Certificate of Appropriateness

Property	2550 N. 47TH ST. N. 47th Street Historic District
Description of work	Remove inappropriate, mis-matched tuckpointing on house and garage. Re-point all prepared joints with new, matching mortar. Replace all missing mortar on the house. Install new brick in place of broken or spalled original brick. Install a cap on the chimney that will not be visible from the ground. Install new wood guard railing on second story rear porch deck.
Date issued	6/6/2014 PTS ID 95361 COA, tuckpointing and porch railing

East elevation with second floor porch

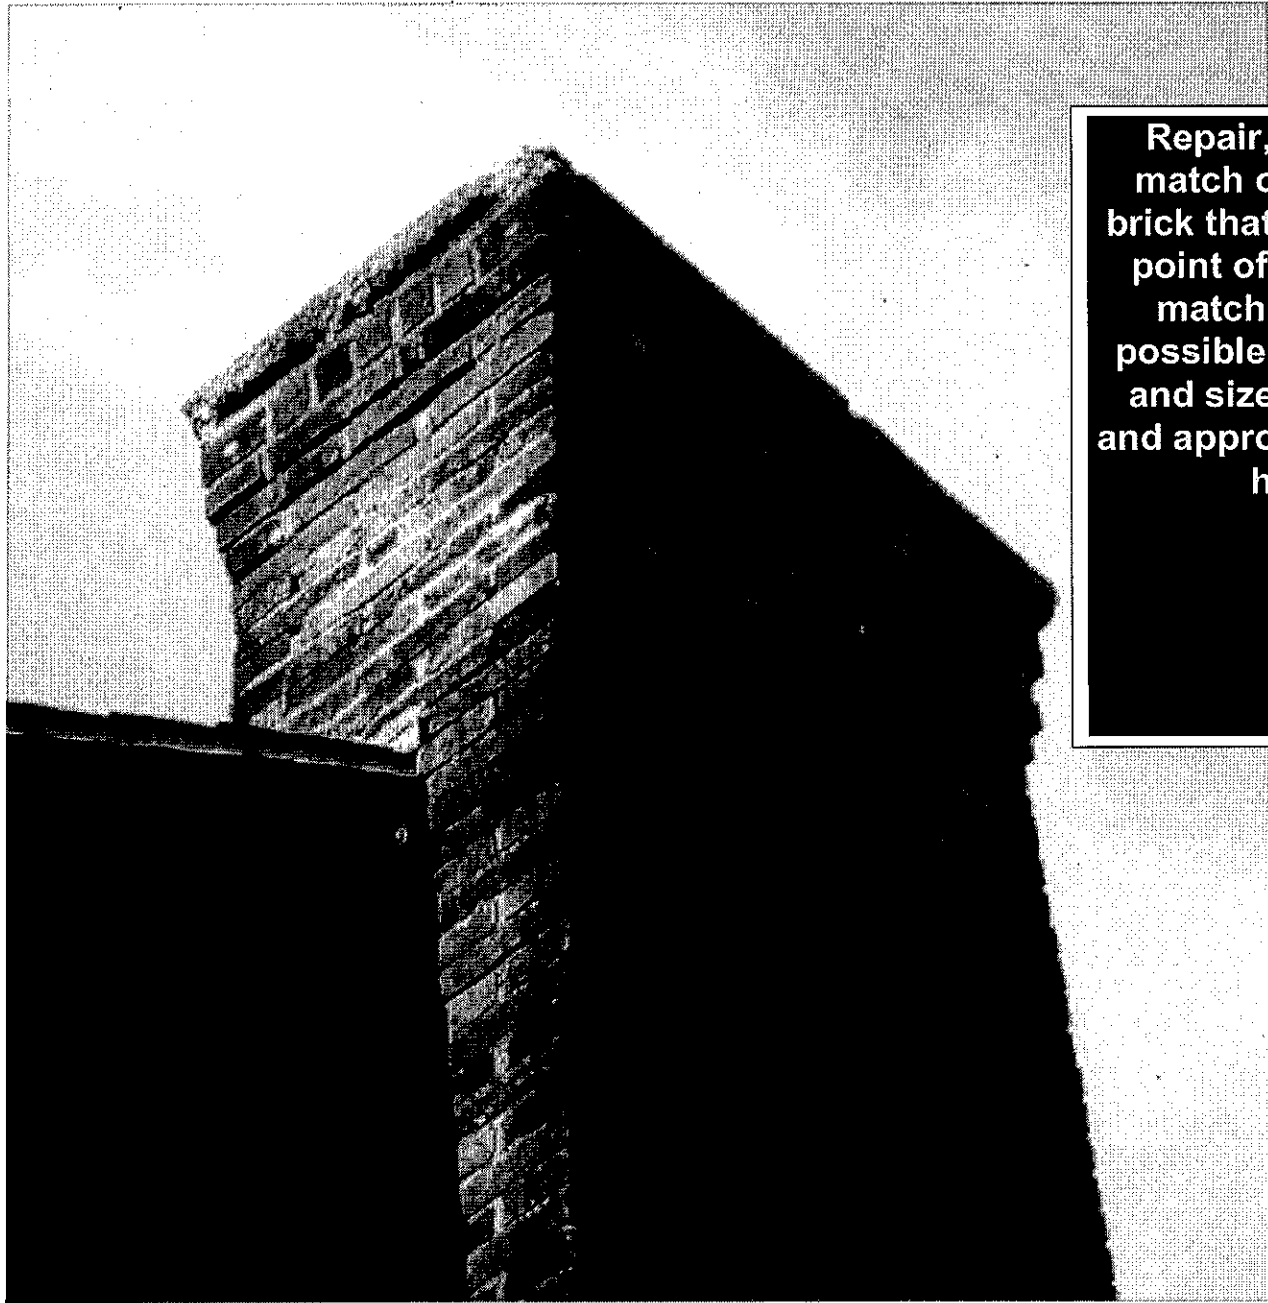
Build new wood guardrail around upper porch deck. Plans are below.

Remove poorly tuck-point joints and install mortar that matches the original in terms of color, texture, joint width and joint finish. Mortar no harder than type O should be used and preferably type K. A sample panel of tuckpointing, dried for three days must be reviewed and approved by HPC staff prior to general installation of the material. The panel needs to only about 1 foot by 2 feet.

Tuck-point areas such as these where mortar has washed away. Repair flat roofed deck above if necessary.

Repair loose brick and remove in appropriate light colored mortar as need and replace with a new mortar that matches the original in terms of color, texture, joint width and joint finish. A sample panel must be reviewed and approved by HPC staff prior to general installation of the material.

Repair, rebuild chimney top to match original design. Replace brick that are damaged beyond the point of re-use. New brick must match originals as closely as possible in terms of color, texture and size. HPC staff must review and approve any new brick used for house and garage.
